Network Code Requirements for Generators: DSO View

EURELECTRIC Network of Experts TSO-DSO Interface

ACER Workshop, 3 September 2012, Brussels

LFSM-O & -U & Risk of Undesired Islanding

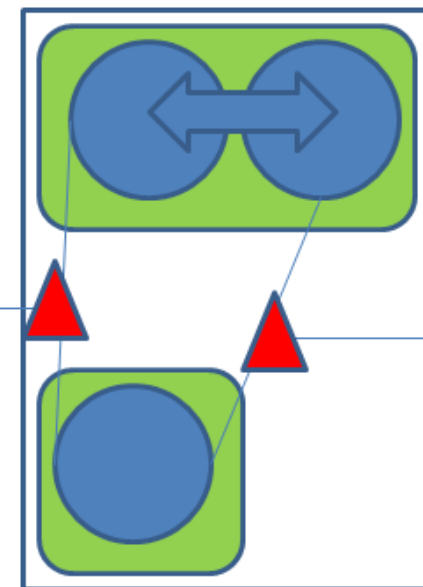
Rule for prevention of electrical risk for personnel in case of incident
= **DISCONNECT!**
Decisive factor for security of supply = **REMAIN CONNECTED!**

- The NC proposes moderation of protection systems by weakening frequency and voltage based protection settings
- Possible negative consequences:
 - An unacceptable increase of electrical risk in distribution networks in some countries
 - Damages to generators and consumer appliances (under islanding operation)
- The network code should not preclude technical solutions that would ensure the quality and safety of networks operation (currently in a demonstration phase)
 - DSOs offer their contribution to the CBA on this requirement
